This is to certify that City Of Portland/n/a

has permission to Build New 74,000 sq. Ft. E

AT 358 Eastern Promenade

Permit Number: 041016

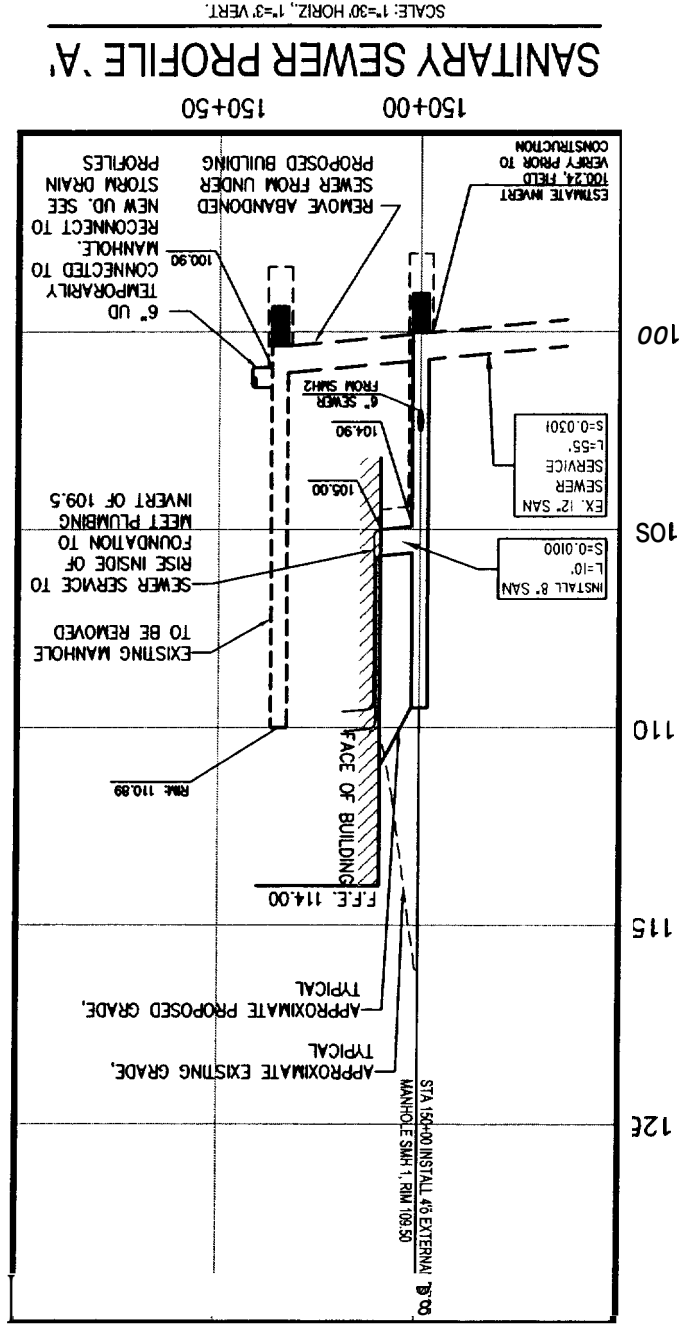
Enclosed are three sketches which show the additional sewer service which will lead to the classroom wing. Please note that the sewer will enter the building lower than required by the mechanical engineer. This is to protect the sewer outside of the building from freezing.

FIGURE  
**RFI #3-B**

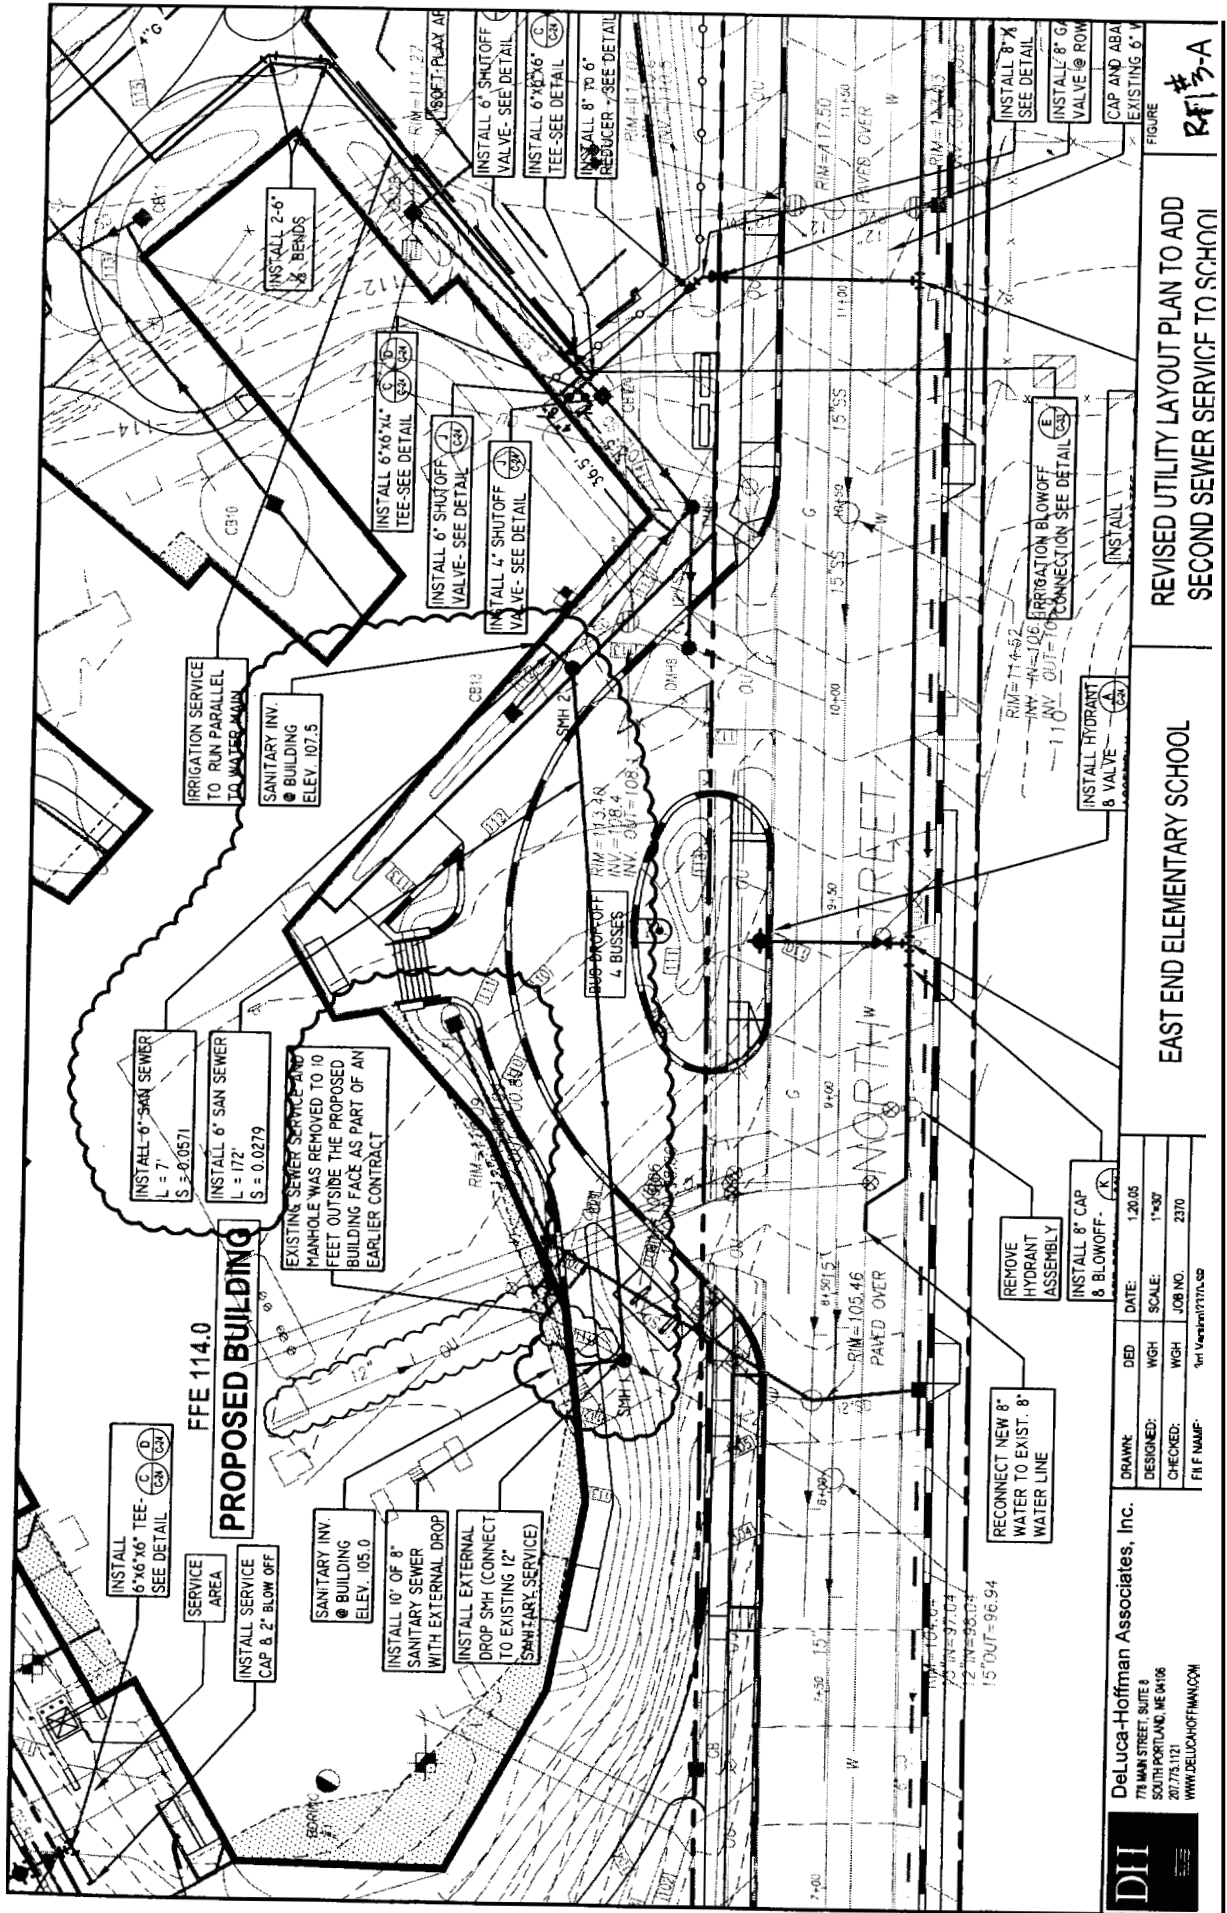
REVISED SAN SEWER PROFILE 'A' TO ADD  
 SECOND SEWER SERVICE TO SCHOOL -  
 APPEN. CALCULATED PROFILE 'A'

1. Bill Hoffman of Deluca-Hoffman has provided a cover letter on additional sanitary sewer line and 3 sketches RFI #3A, RFI #3B, RFI #3C all dated 1.20.05. Please coordinate with required elevations on these sketches for the sanitary sewer line to obtain proper protection from freezing.

FIGURE  
RFI # 3-C

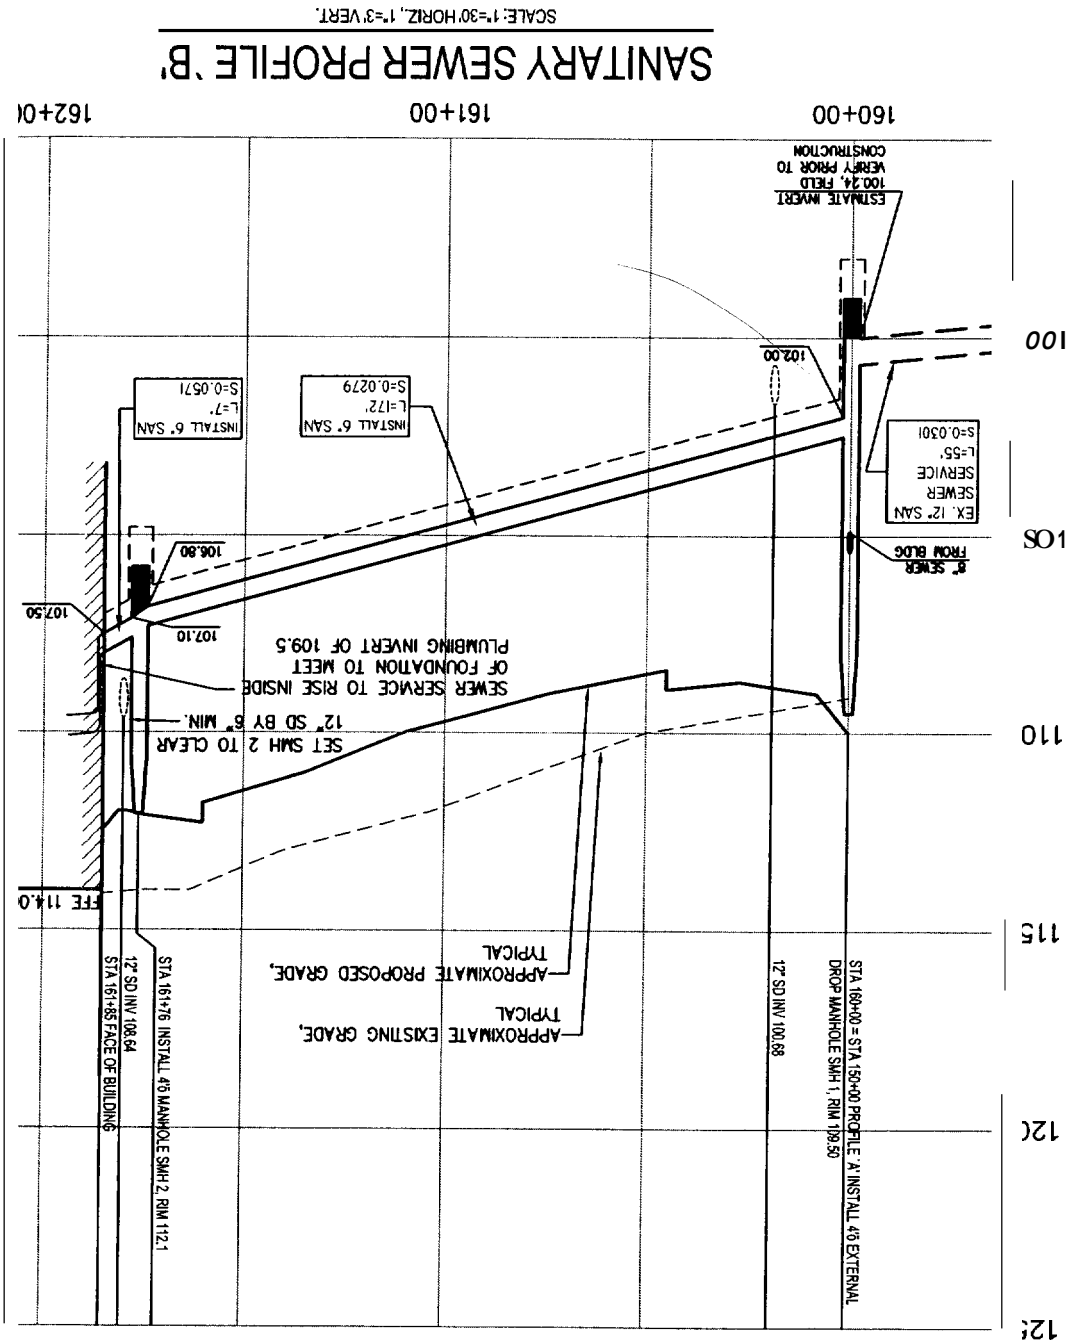
REVISED SAN SEWER PROFILE 'A' TO ADD  
SECOND SEWER SERVICE TO SCHOOL -  
ADDED SAN SEWER PROFILE 'B'

**ASK-10**

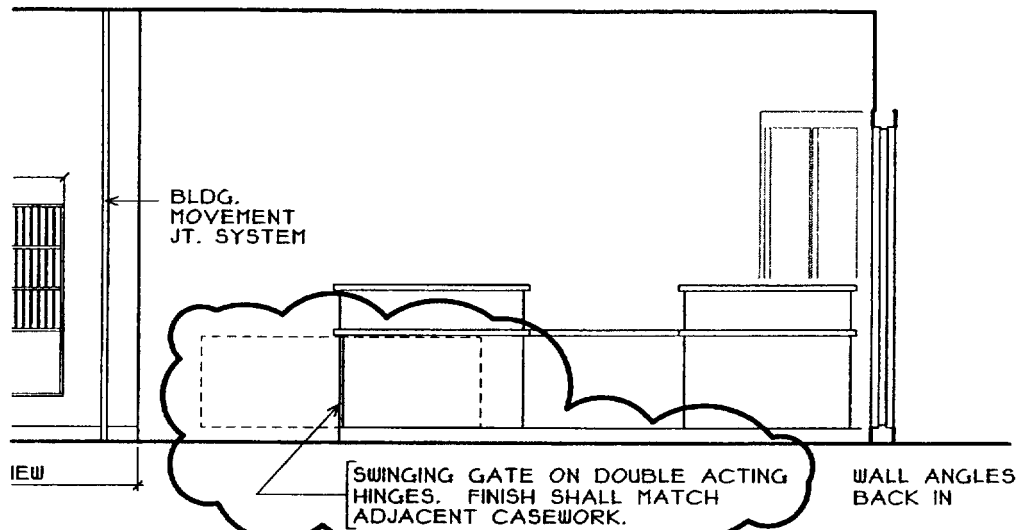
**ADD:** Wall Section 50/A3.13 at Alternate #8 Light Shafts per attached ASK-10.

ASK-12

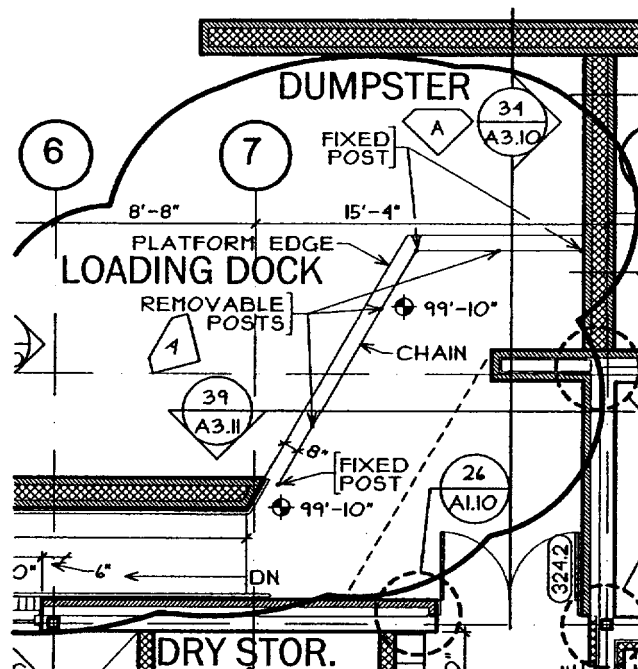
**ADD:** swinging gate at Front Office 105 as indicated in attached ASK-11 & ASK-12.

# ASK-4

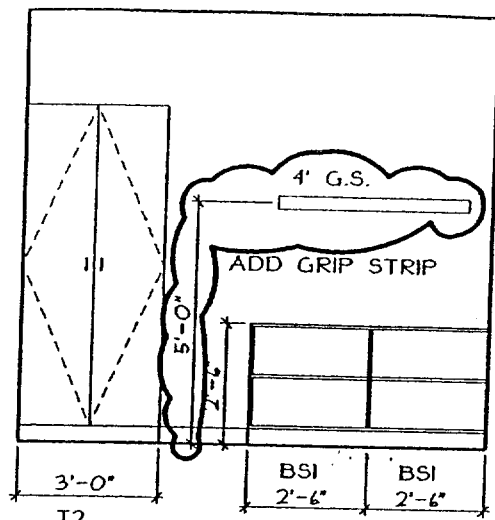
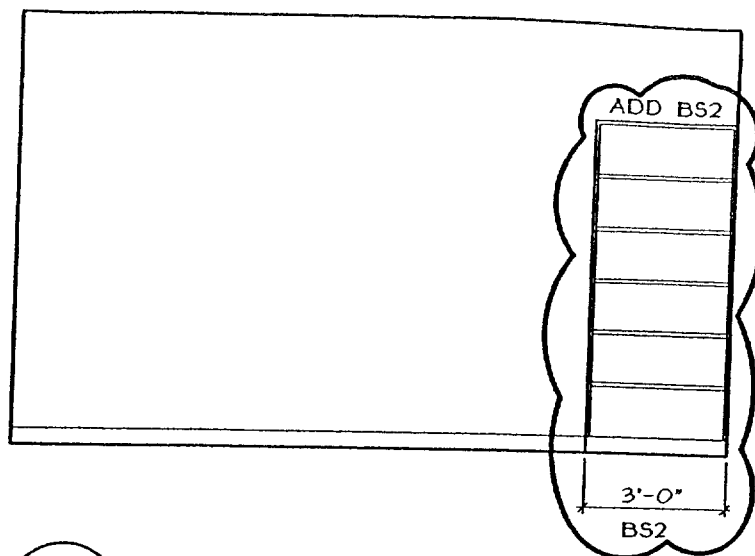
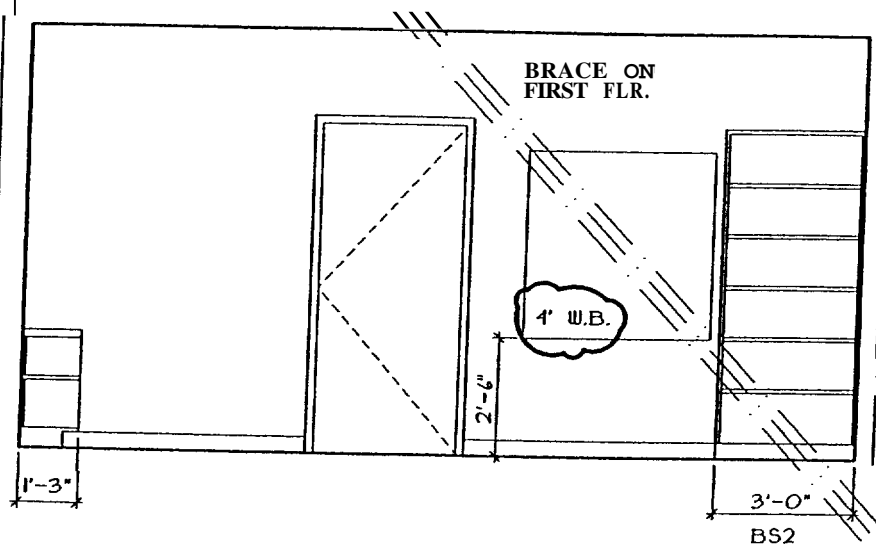
**CHANGE:** Interior Elevation 1/A1.4 per attached ASK-4.

**ASK-7**

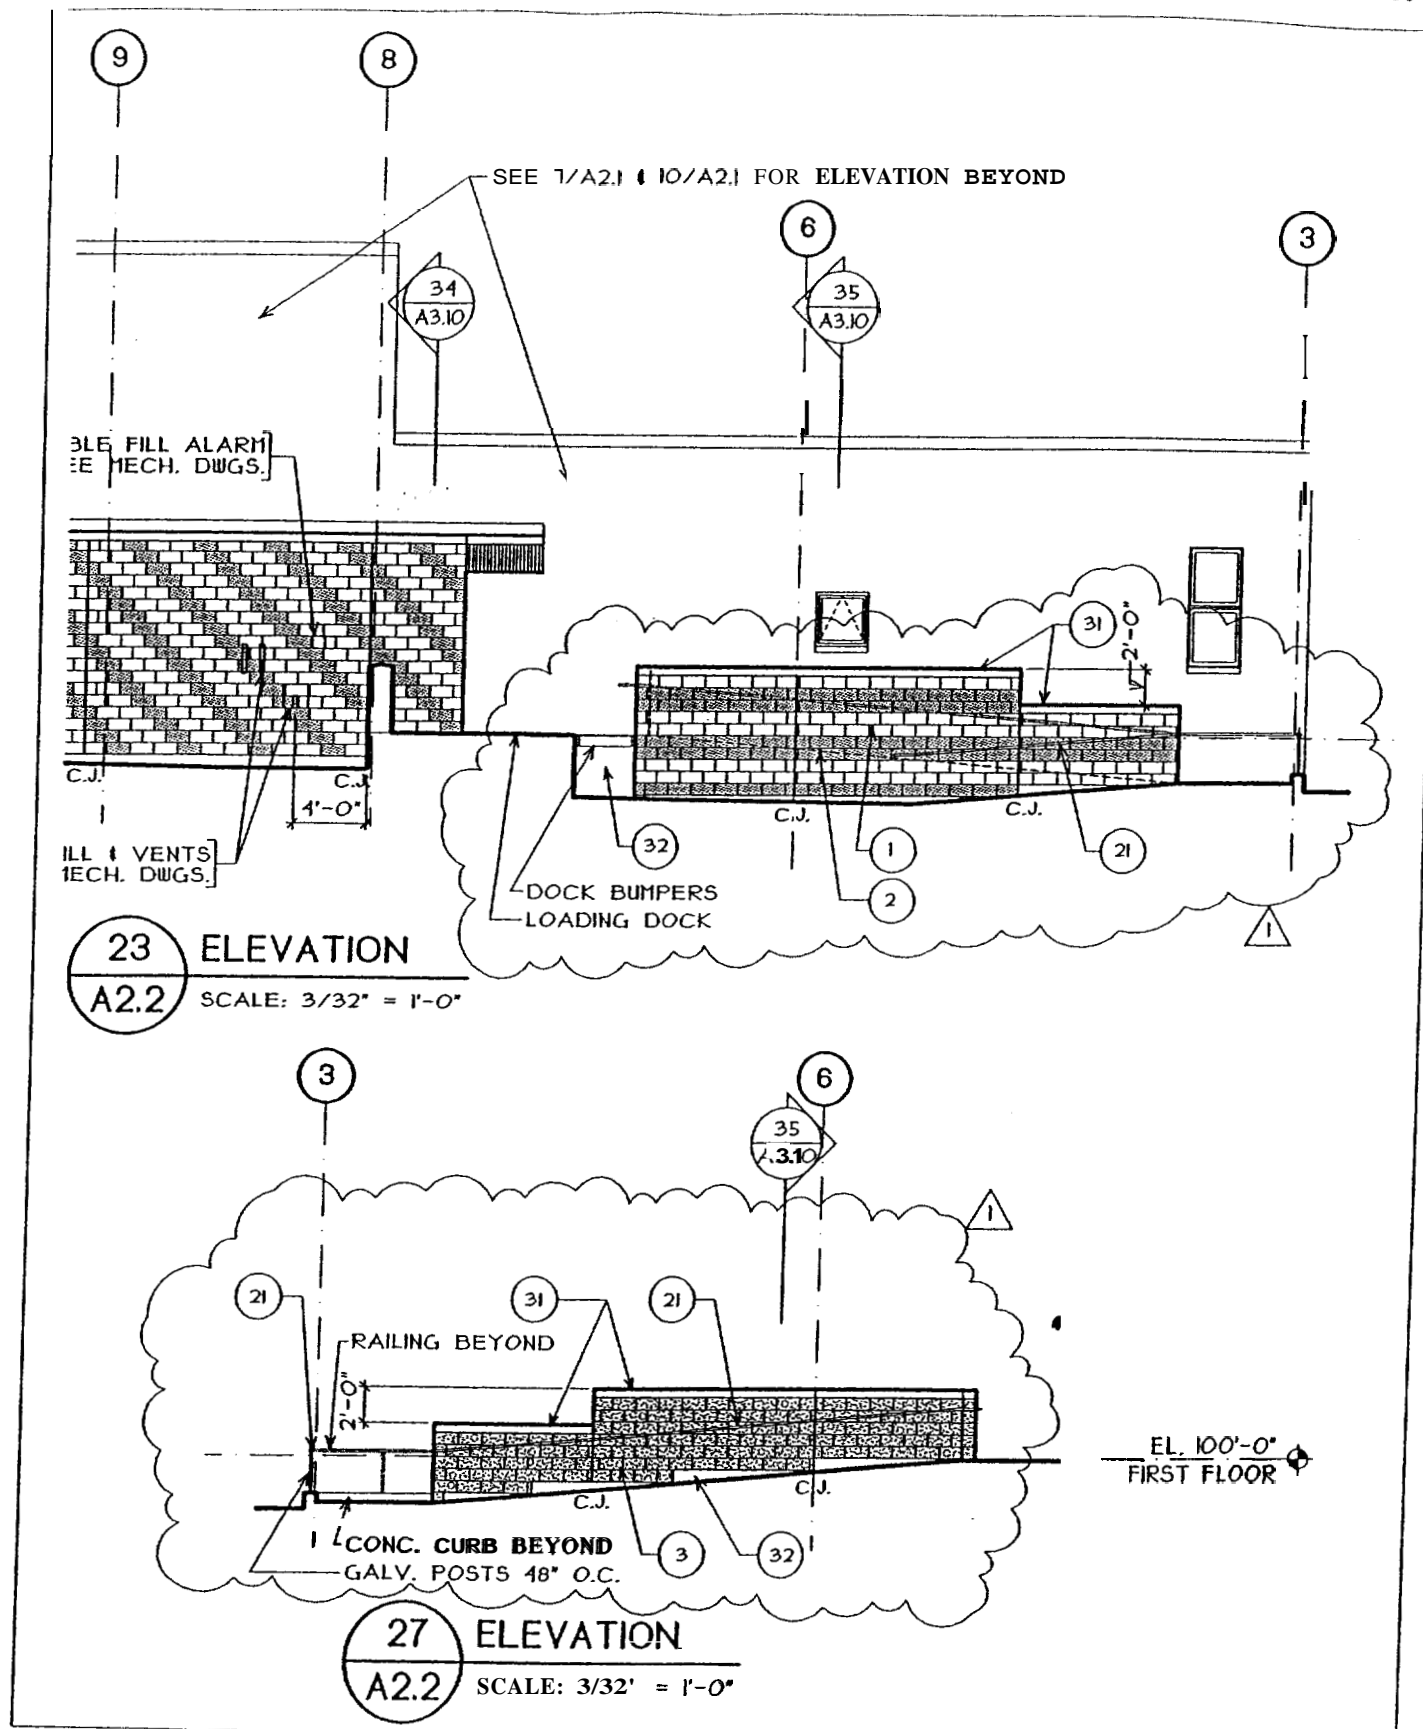
**CHANGE:** Elevations 7/A2.1 and 10/A2.1 per attached ASK-7.
